Supporting Information for Tx Power Excursion

Comment 38

Broadcom Inc.

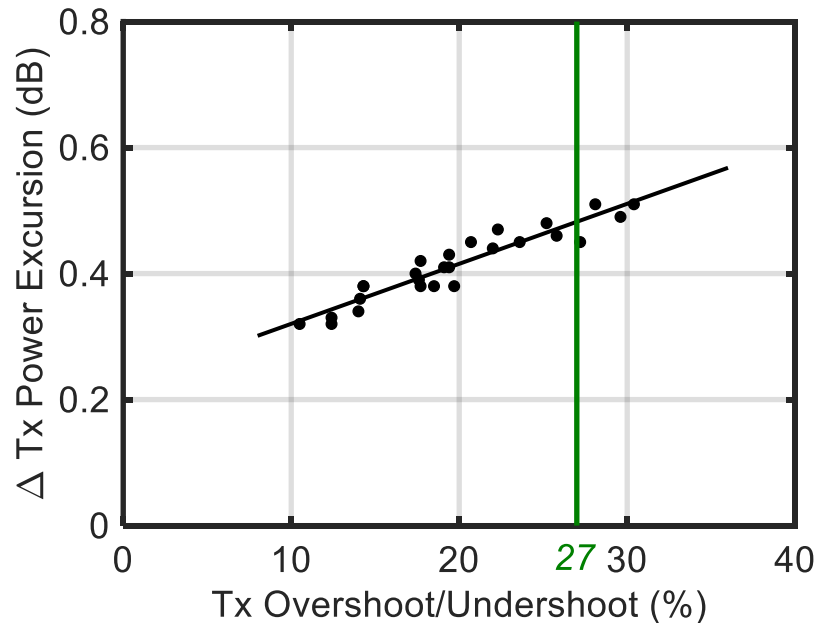
Transmitter power excursion (max) was 2.3 dBm measured with a hit ratio of 3×10^{-3} . The hit ratio was subsequently changed to 1×10^{-4} with an editors' note to revise the value for Tx power excursion.

- Tx power excursion (max) was changed from 2.3 dBm to 2.9 dBm in Clause 180 P802.3dj after hit ratio was changed from 1×10^{-2} to 1×10^{-4} , [johnson_3dj_01_2607](#)

- Tx power excursion of 2.8 dBm at 1×10^{-4} HR is equivalent to 2.3 dBm at 3×10^{-3}

Transmitter power excursion, each lane (max) 2.8 dBm
